City of Biddeford
Planning Board
August 16, 2023 6:00 PM City Hall
Council Chambers, & Zoom
<https://biddeford.zoom.us/j/94983531202?pwd=Q3ZyejcyUVpBaUVVMHduYXJhSzB4UT09>
Webinar ID 949 8353 1202; Passcode 223739

- 7. NEW BUSINESS**
 - 7.A. 2023.29 Public Meeting and take comments regarding Phase I of a Preliminary Subdivision Plan Application for One Diamond Development, LLC to construct 477 residential units, multi-unit buildings and commercial space at 1 Diamond Street (Tax Maps 40 & 37, Lots 25-1,25-2,24,25,34 & 35) in the B1 & GD1 and in the shoreland overlay zone.

[2023.29 One Diamond Master Plan and Phase 1 PRELIMINARY PLAN Planners Report 2 8-10-23.pdf](#)
[One Diamond Site Plan Application Materials 2023-06-14 18462.pdf](#)
[One Diamond - Full Plan Set to City of Biddeford 2023-06-14 18462_Reduced \(2\).pdf](#)
[2023-08-01_Diamond Match Phase 1 Preliminary Submittal - PW Comments.pdf](#)
[Response to Public Works Comments recieved 08-03-2023.pdf](#)
[Galbraith 08-10-23.pdf](#)
[One Diamond SLODA 2023-06-14 18462.pdf](#)

UTILITY PLAN - PHASE 1 - AREA 1A	
OF:	
ONE DIAMOND	
ELM STREET	
BIDDEFORD, MAINE	
FOR:	
ONE DIAMOND DEVELOPMENT, LLC	
2 LIMEWELL DRIVE, SUITE 201	
KENNEBUNK, ME 04043	
DESIGNED	TFG
DRAWN	DAB
CHECKED	CAB
DATE	04/12/2023
SCALE	1" = 20'
PROJECT	18462
SHEET 28 OF 51

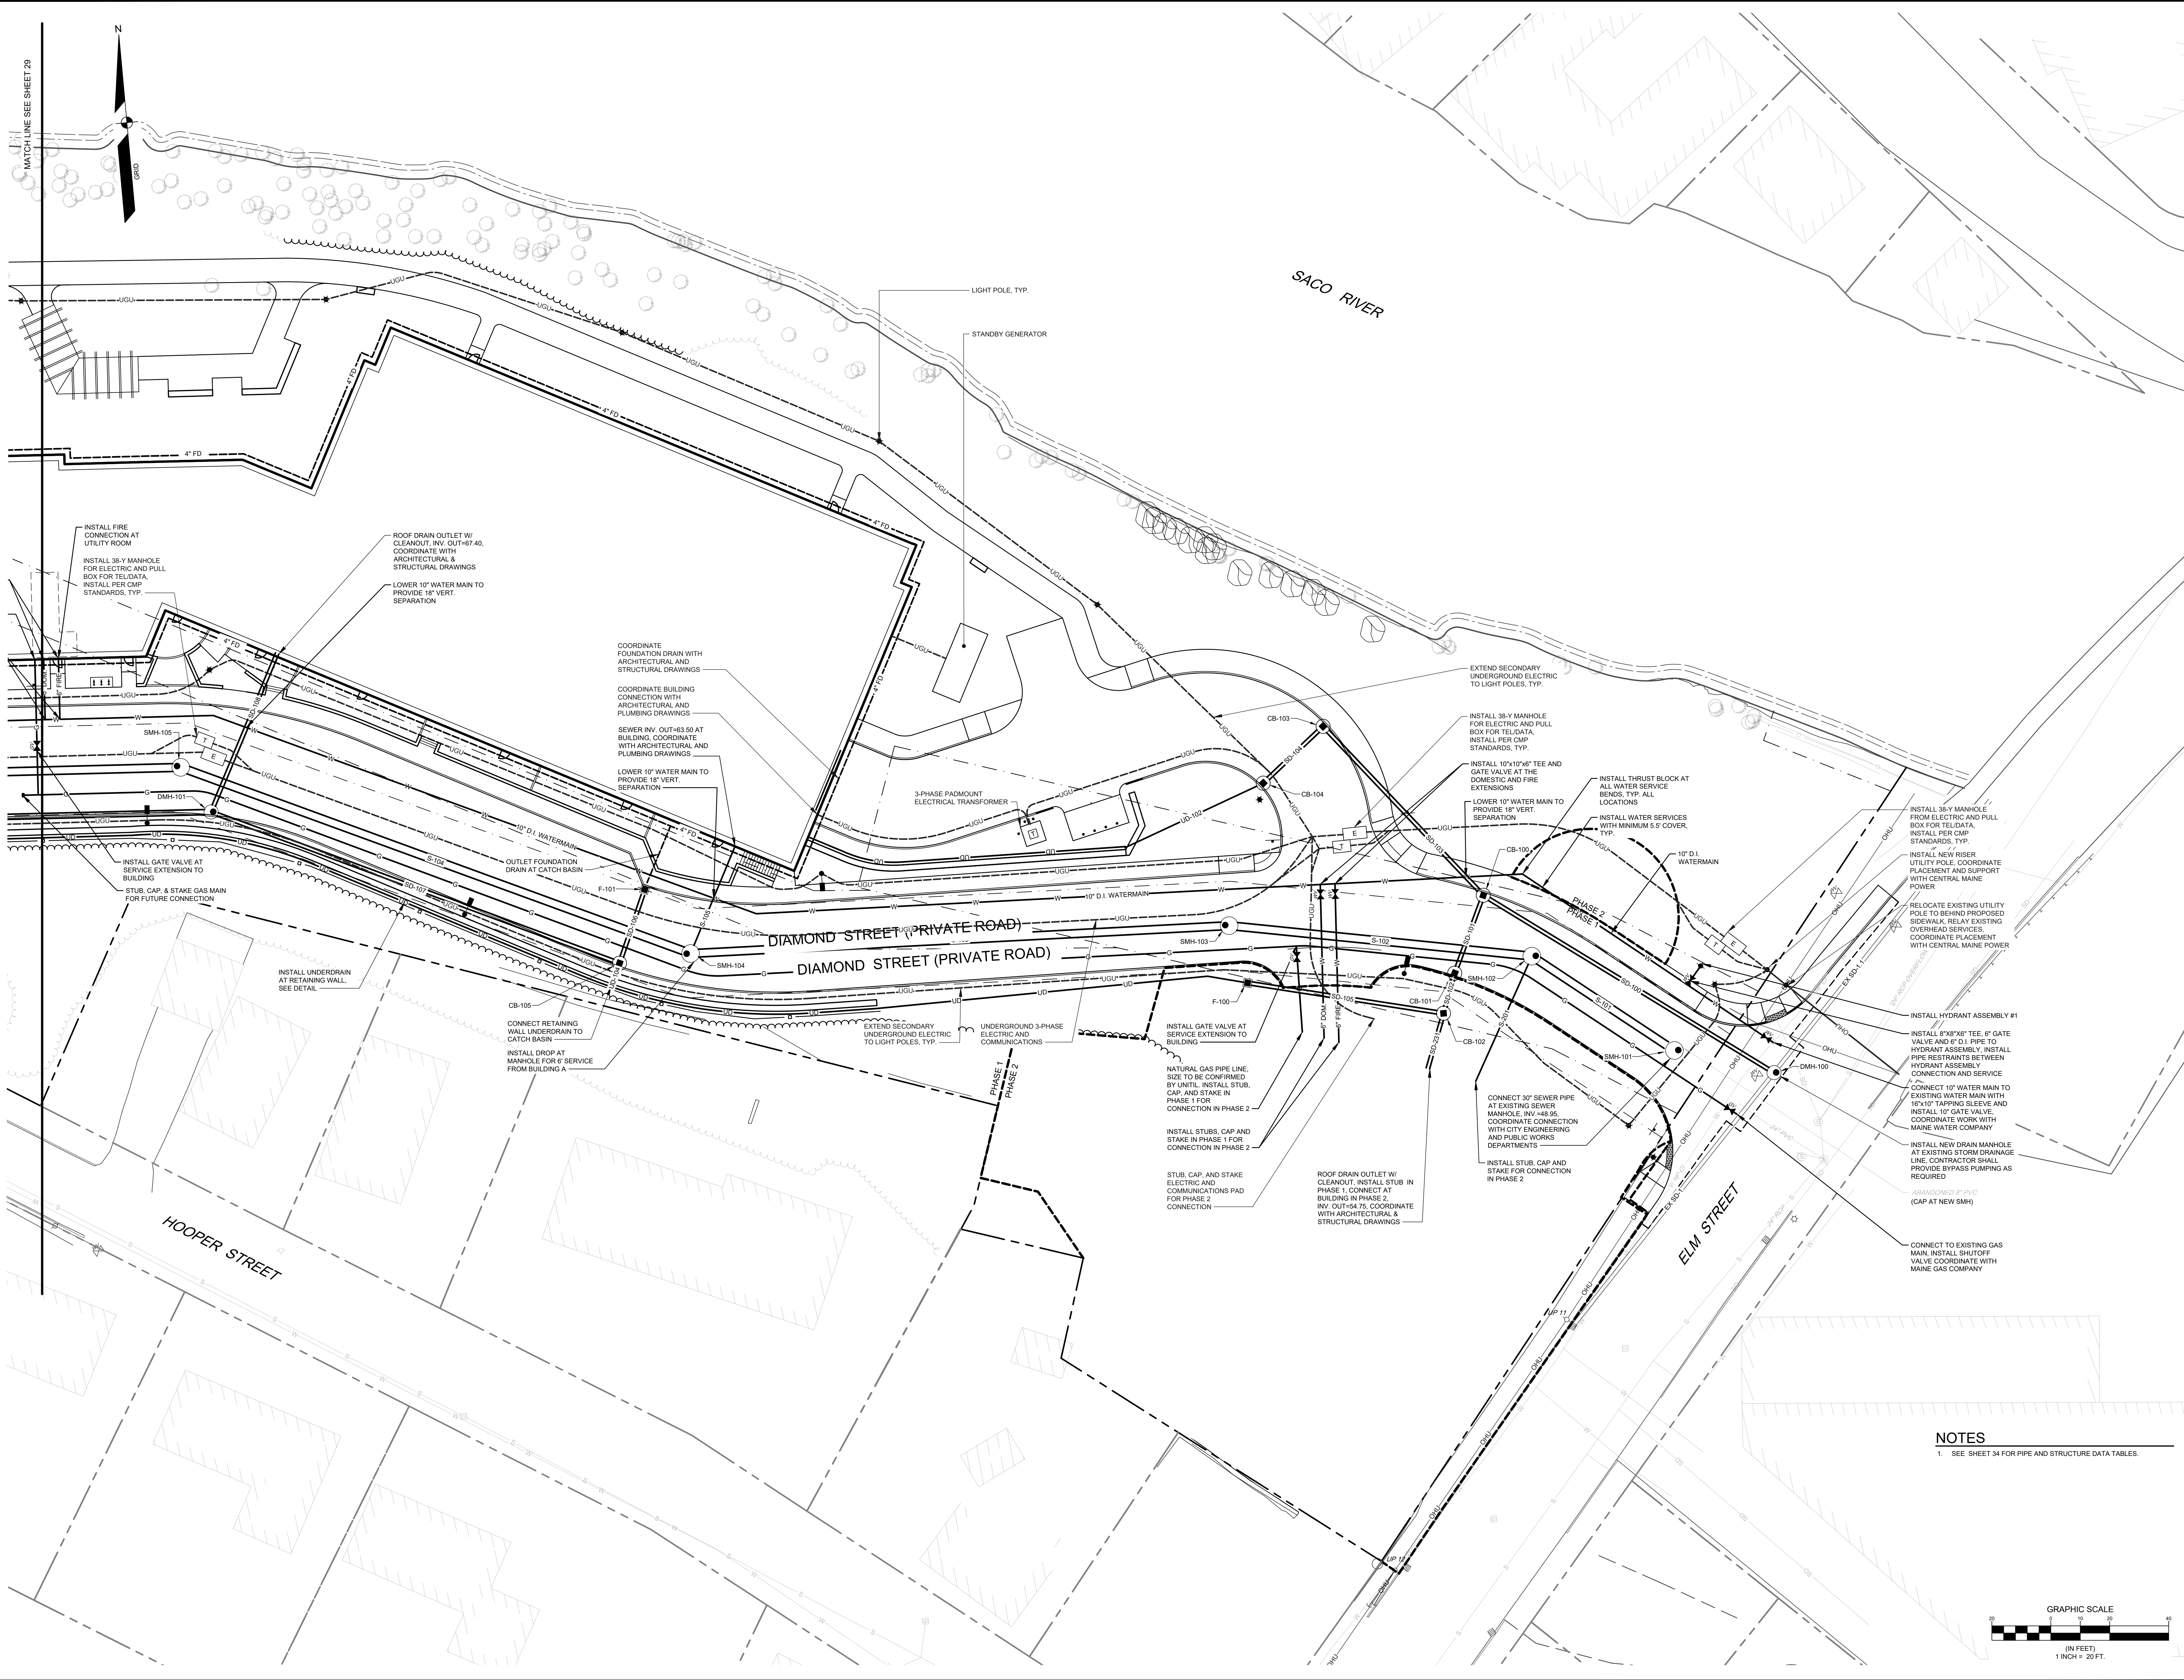
14. Sheet 28 – Utility Plan

All of the preliminary plan rim and invert information is provided on the structure tables (Sheet 34) for clarity and plan legibility. Contours are presented on the grading plans for clarity.

SHEET 31 OF 51

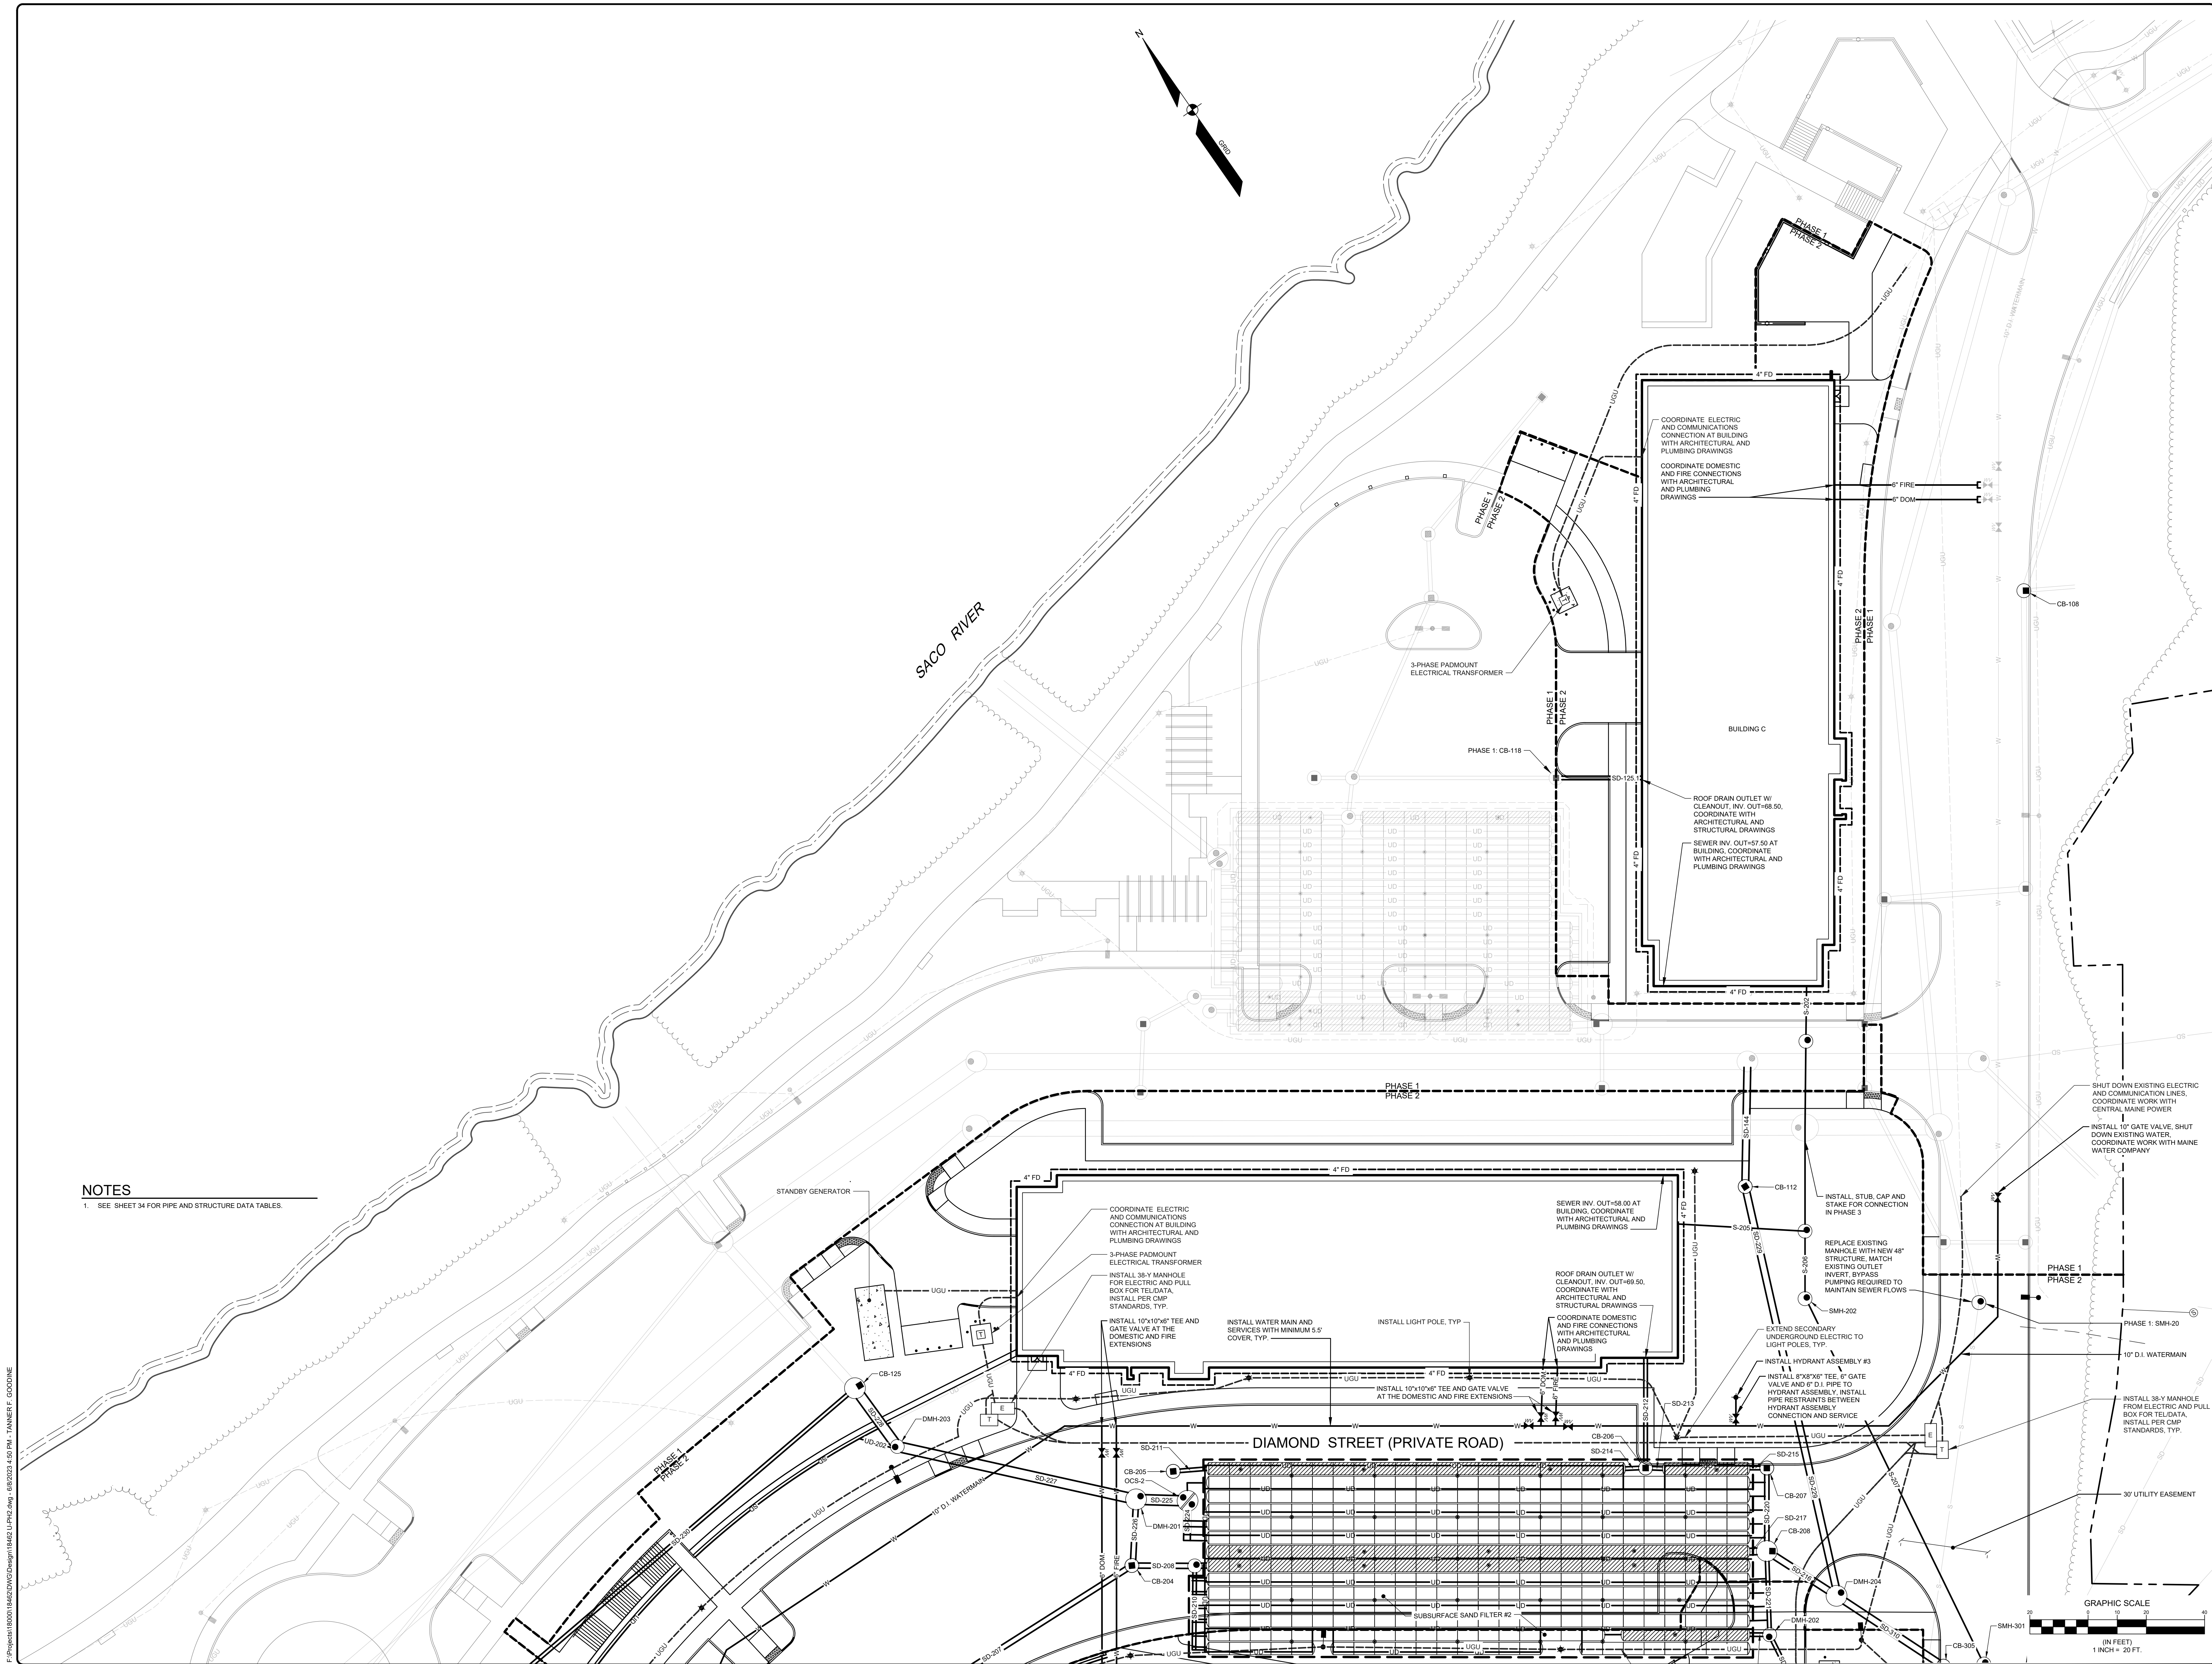
15. Sheet 31-32 – Utility Plan (Phase 2/3)

- b. *I thought Building E&F are Phase 3? (sheet 32)*

Sheet 32 will be revised to include notation clarifying the phase limits. The proposed phasing is presented on Sheet 4 of the plan set.
